ALBUQUERQUE
INTERNATIONAL AIRPORT
CENTER TAXILANE REHABILITATION
CITY OF ALBUQUERQUE NEW MEXICO
A.I.P. NO. 3-35-0003-04

DESCRIPTION	SHEET NO.
TITLE SHEET, LOCATION MAP AND INDEX OF DRAWINGS	1 OF 9
PROJECT LOCATION PLAN	2 OF 9
LEGEND, GENERAL NOTES AND TABULATION OF QUANTITIES	3 OF 9
PAVEMENT AND UTILITY REMOVAL PLAN	4 OF 9
PROJECT LAYOUT PLAN	5 OF 9
GRADING PLAN	6 OF 9
CONCRETE PAVING JOINT LAYOUT	7 OF 9
PAVING SECTIONS, CONCRETE ENCASED DUCTS AND JOINT SEALANT DETAILS	8 OF 9
MISCELLANEOUS DETAILS	9 OF 9
CHANGE ORDERS NO. 1, 2 AND 3	9A

CITY OF ALBUQUERQUE MUNICIPAL DEVELOPMENT DEPARTMENT ENGINEERING DIVISION					
TITLE: ALBUQUERQUE INTERNATIONAL AIRPORT CENTER TAXILANE REHABILITATION CHANGE ORDERS NO. 1, 2 AND 3					
APPROVALS	ENGINEER	DATE	APPROVALS	ENGINEER	DATE
City Engineer			Liquid Waste		
A.C.E. Design			Traffic		
A.C.E. Hydrology			Water		
DRAWING NO. 2365		MAP NO. M-16		SHEET 9A OF

LOCATION OF RETROREFLECTIVE MARKERS IN SOUTHWEST AREA
SCALE: 1"=50' (CHANGE ORDER NO. 3)

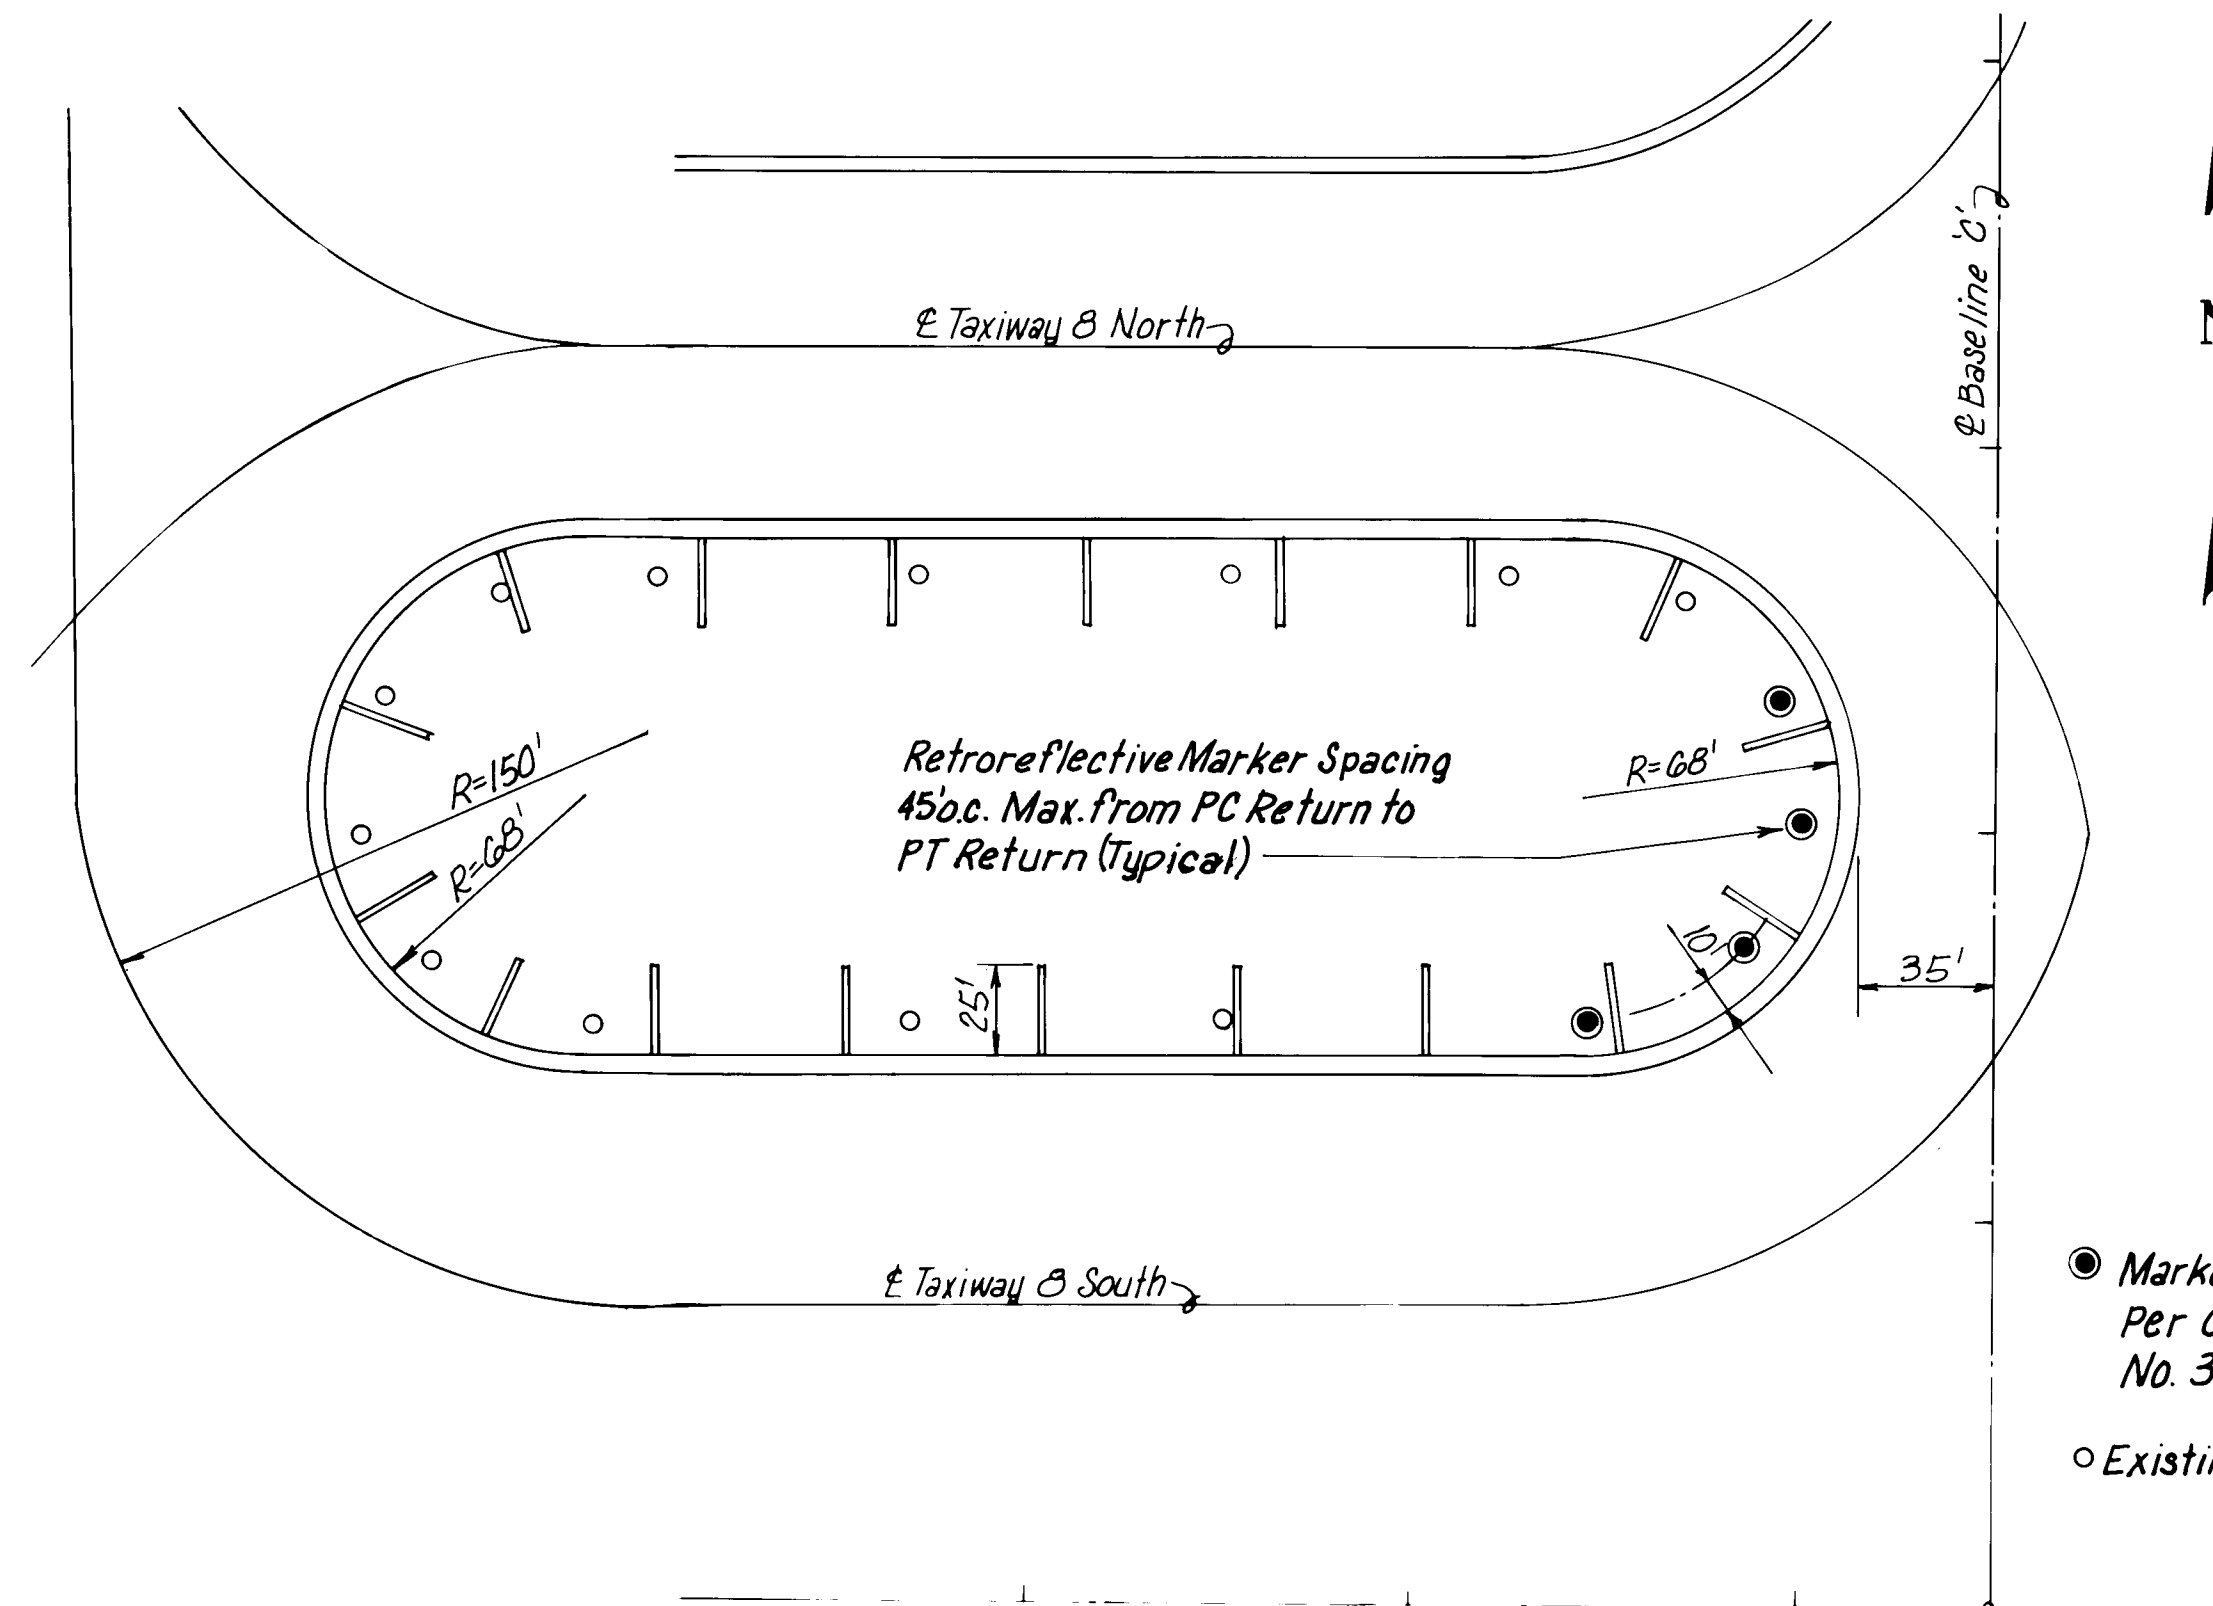
● Markers Installed as Per Change Order No. 3
○ Existing Markers

AIA CENTER TAXILANE
REHABILITATION
SPALL REPAIR DETAIL
CHANGE ORDER No. 1

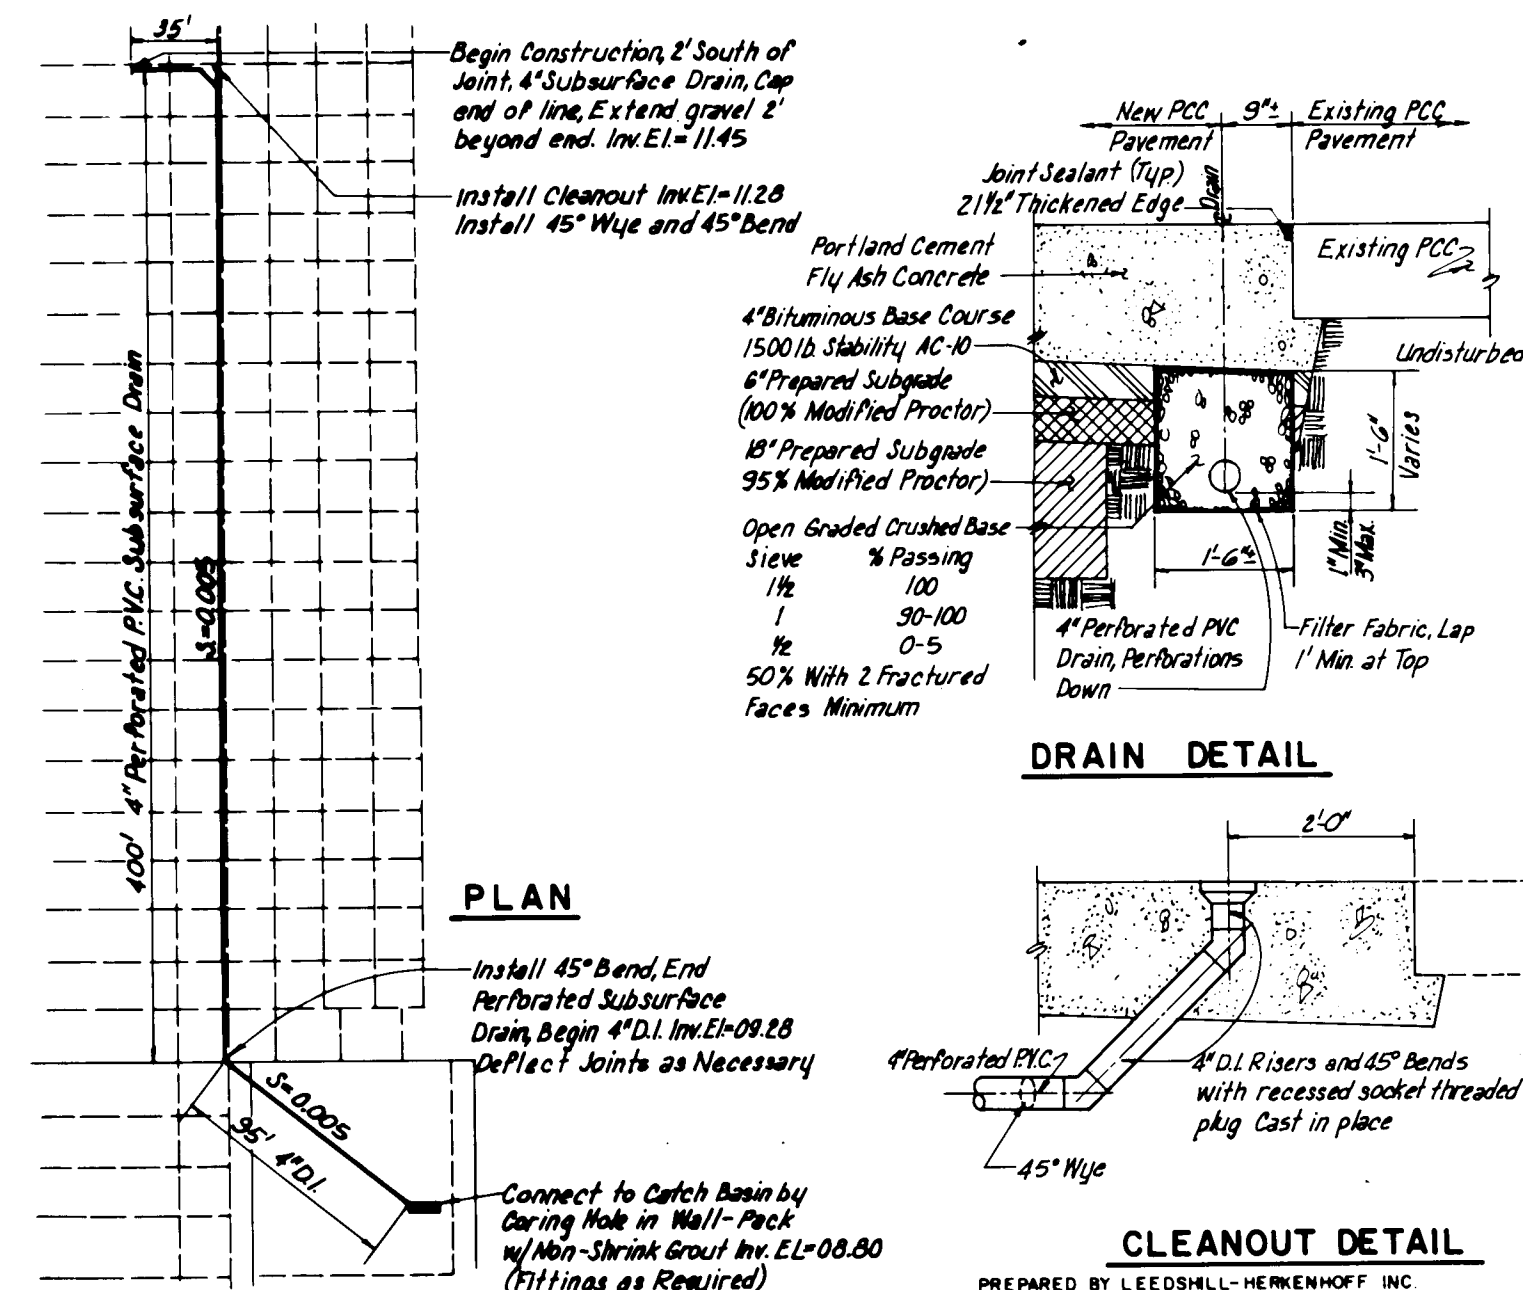
Repair Procedure

1. Saw cut perimeter of repair area minimum 1" depth - do not extend saw cut beyond removal area.
2. Remove concrete from repair area to sound concrete - minimum 1" depth.
3. Sand blast and thoroughly clean all surfaces.
4. Fill repair area using "Set-Instant" Cementitious repair mixture ~~approved~~ in accordance with manufacturers recommendations.
